Technical service bulletin Vent Adaptor Change

The planned change to the GB142 vent adaptor, from aluminum to polypropylene, has now been released to the market. Boilers produced from March 2012, with a manufacturer's date code of '203', will have the new vent adaptor (Fig.1) supplied with the boiler package.

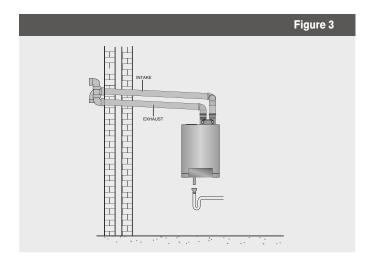
The aluminum vent adapter will be removed from the Low Loss Header Kit due to the product update.

The 3" \times 3" PVC tee will no longer be supplied as it is no longer required in the vent installation.

► The polypropylene adaptor with internal condensate drain means a condensate tee will no longer be necessary in the vent system external to the boiler (see Fig.3).
